## ADDENDUM 2

Project: NMHS Restroom Remodel

Invitation for Bid No.: 25-01-03

Issued by: Christopher Brown, AIA, Arkitek

**ROOF PLAN SKYLIGHT SECTIONS SKYLIGHT PLAN**

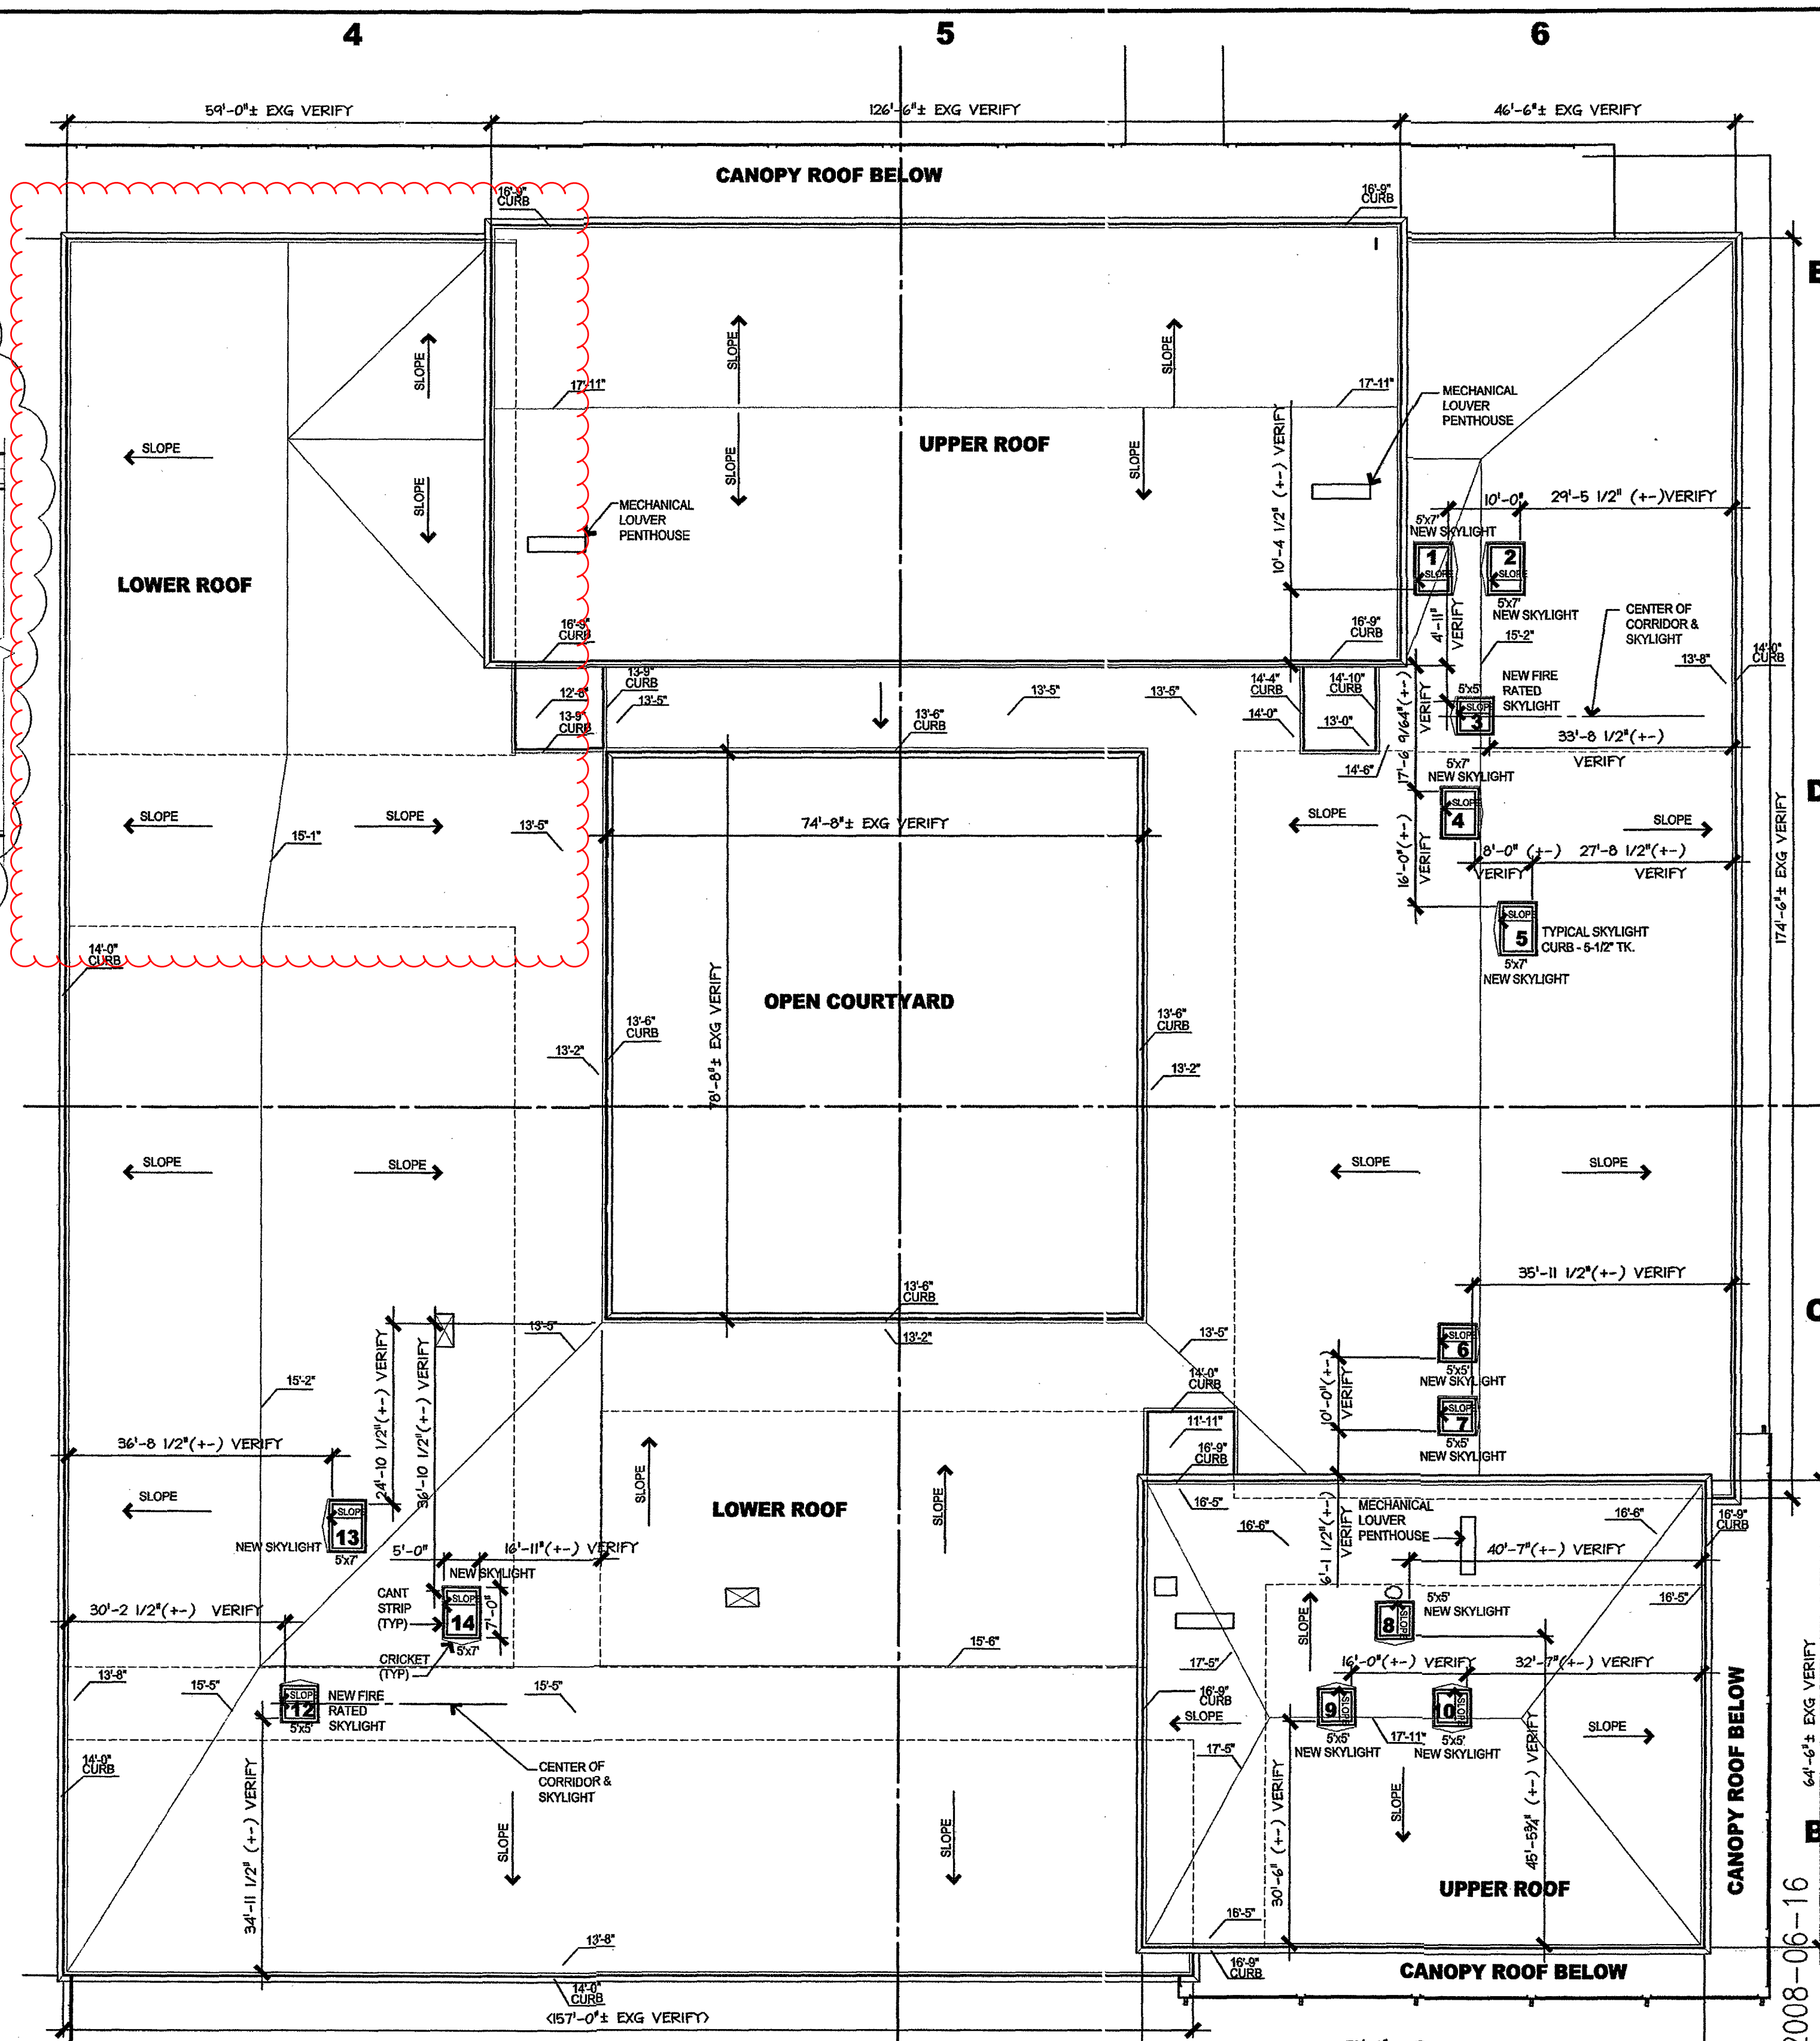
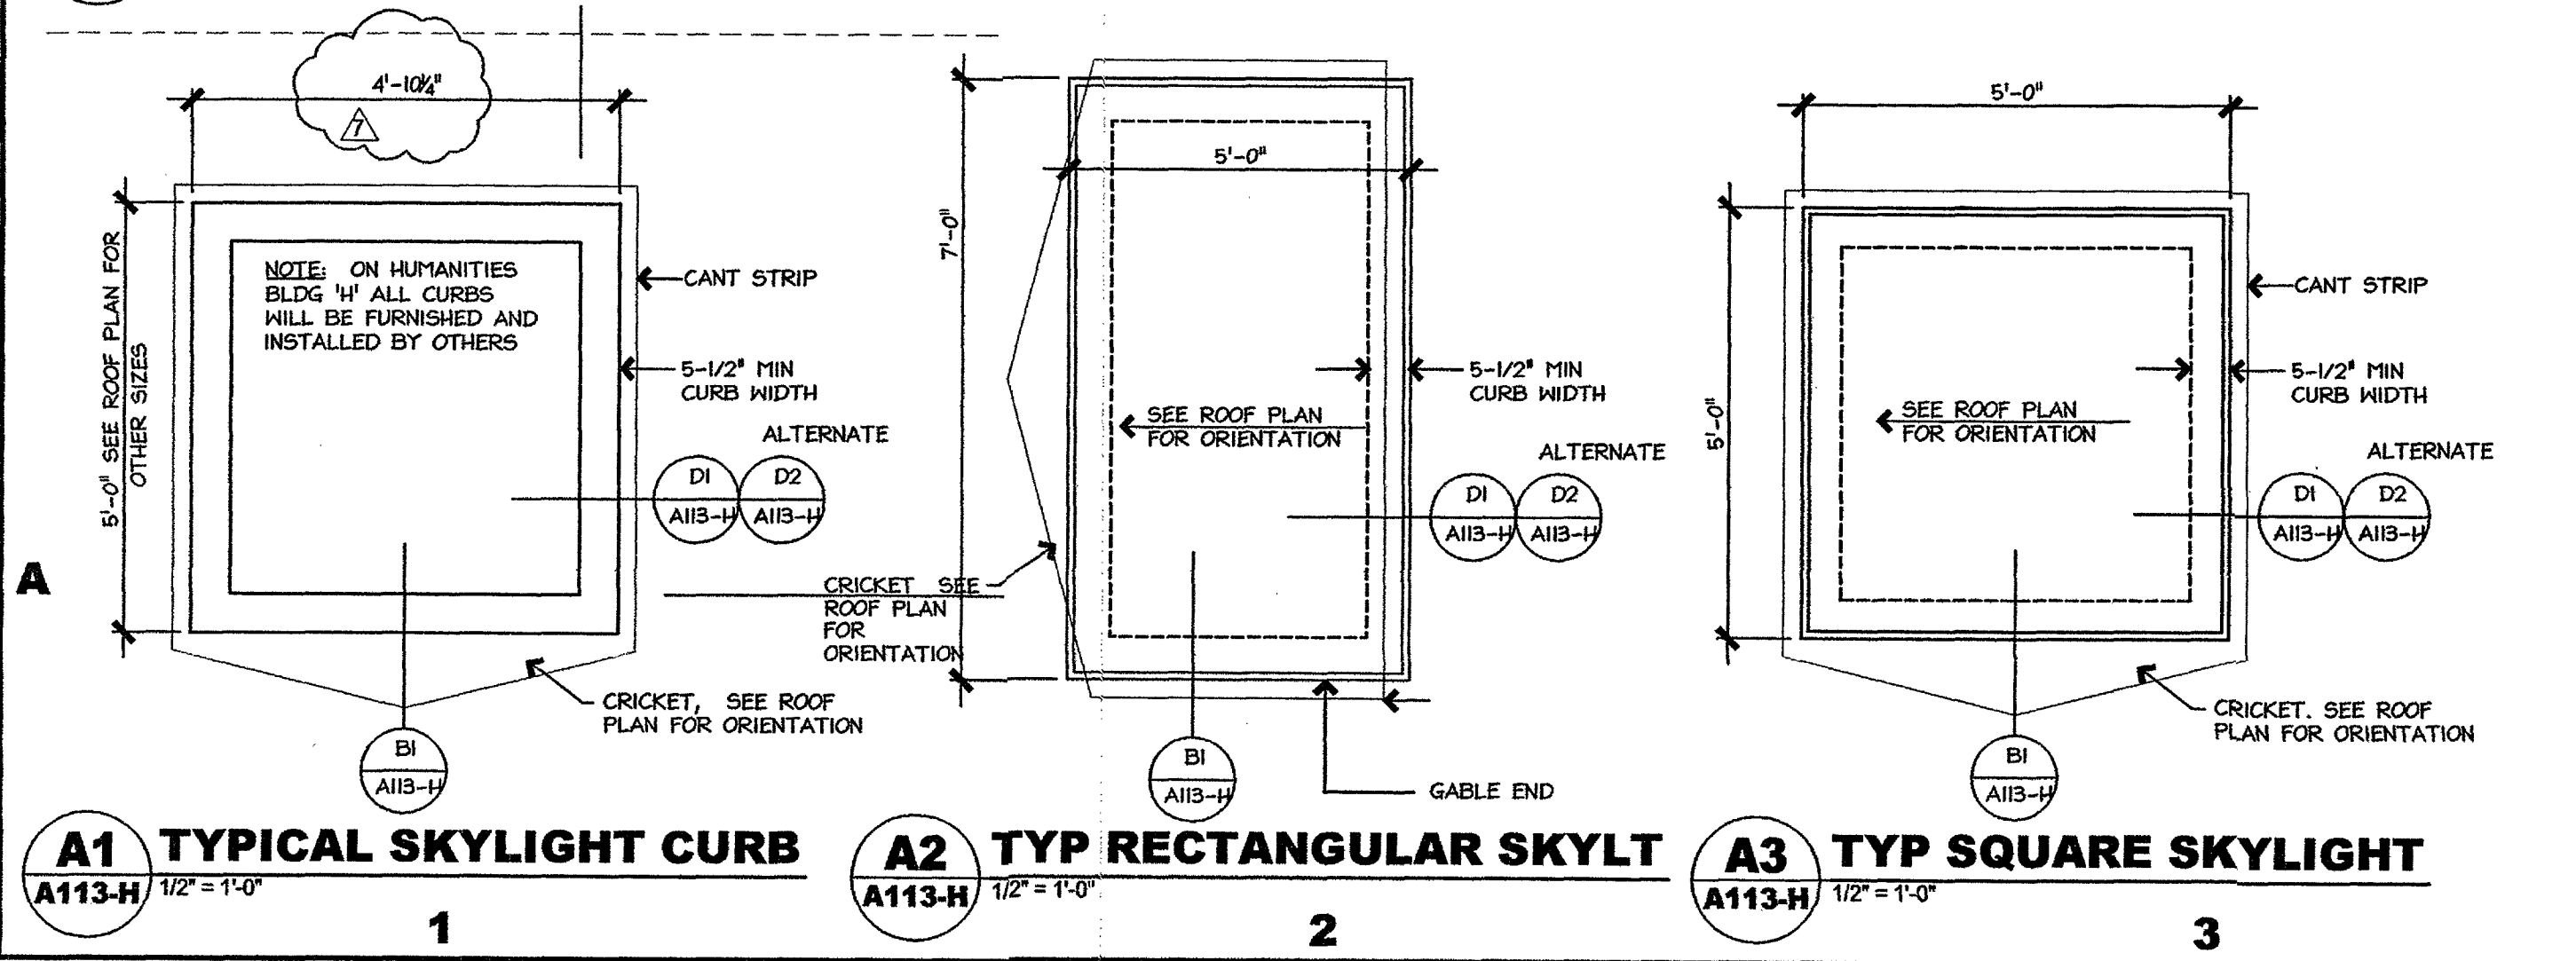
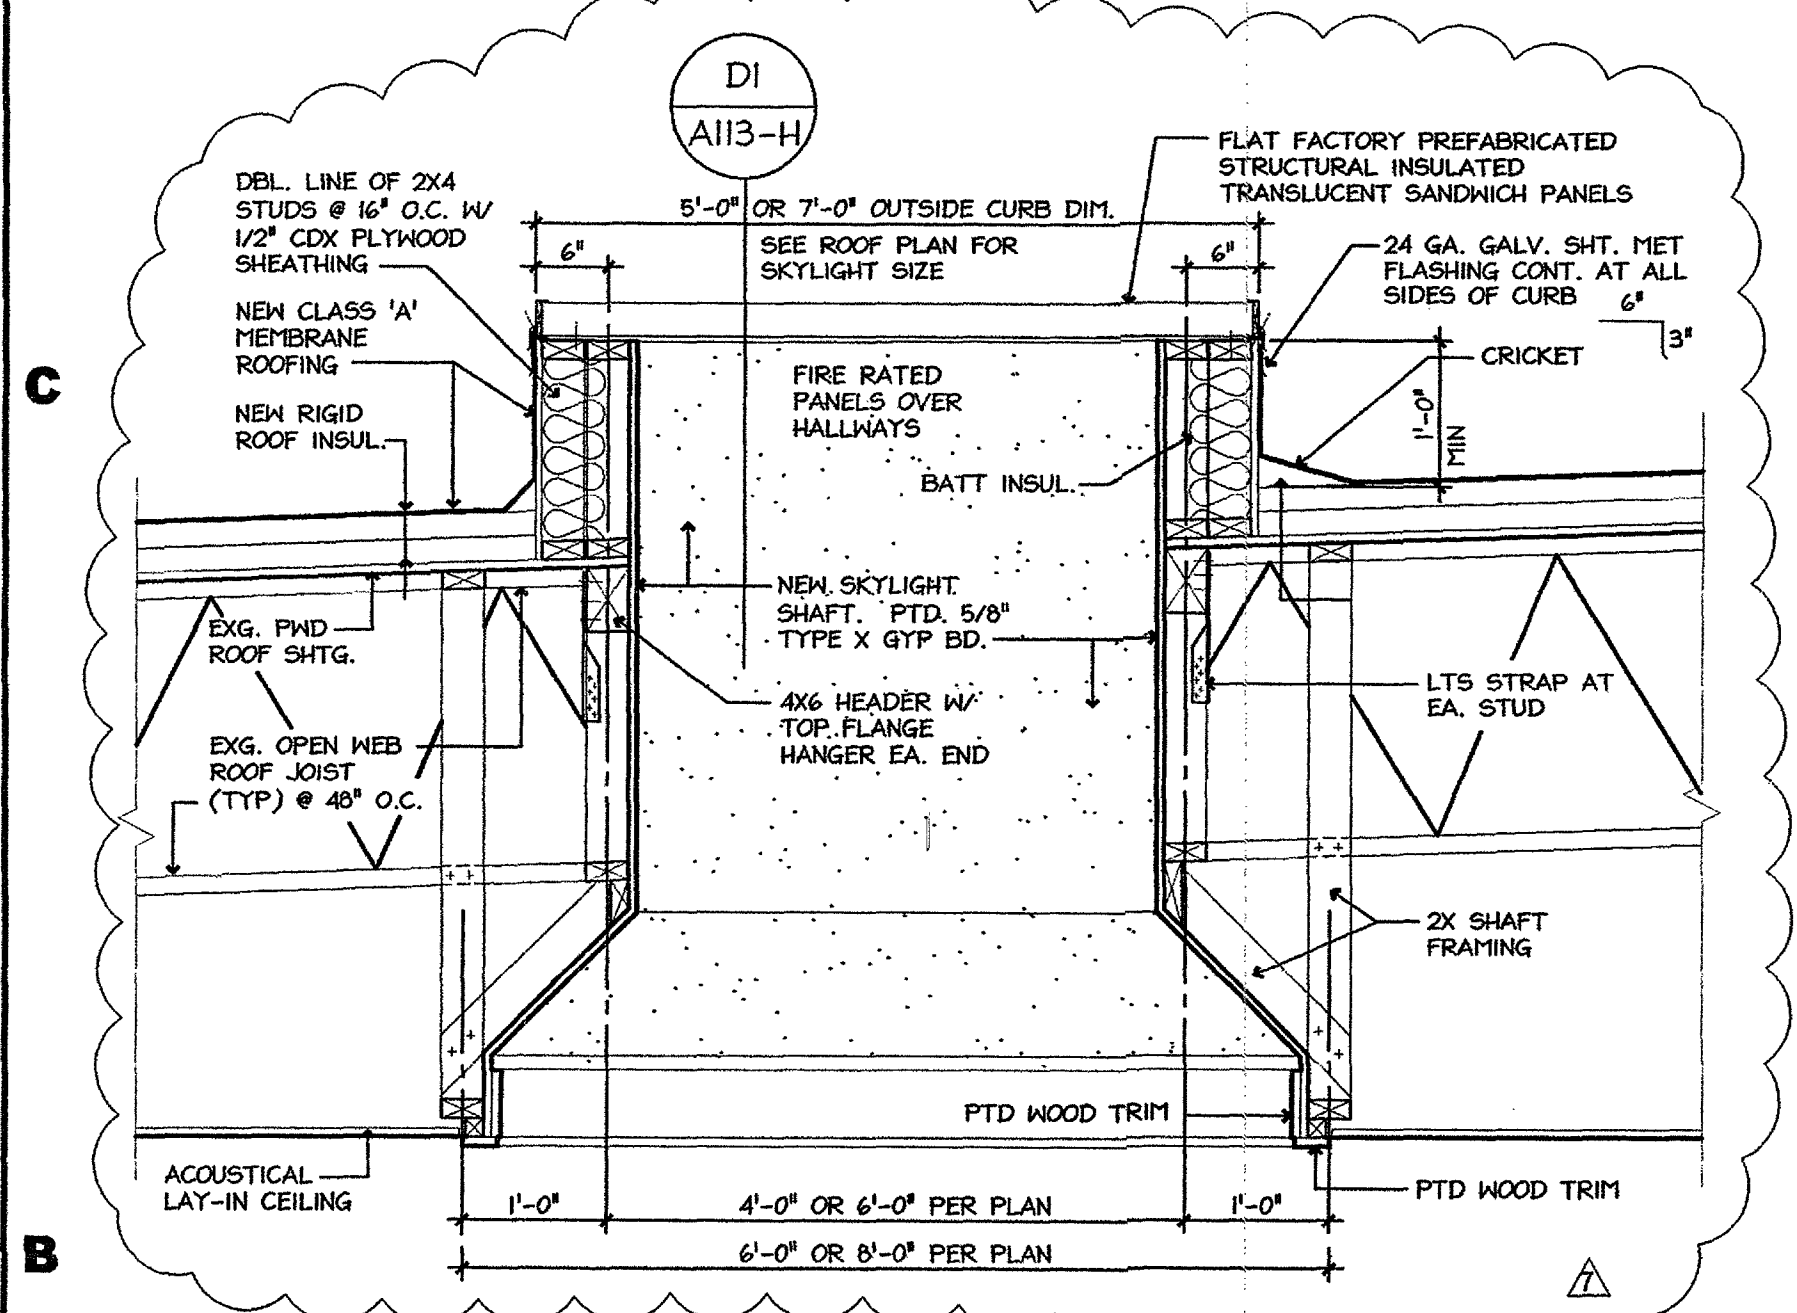
4. Please provide an existing roof detail for patching work at the new exhaust fan EF-B2.  
See the pdf attached with existing roof details from a previous remodel (Pages from NMHS as-builts 2008 – Building ‘H’ Remodel.pdf).
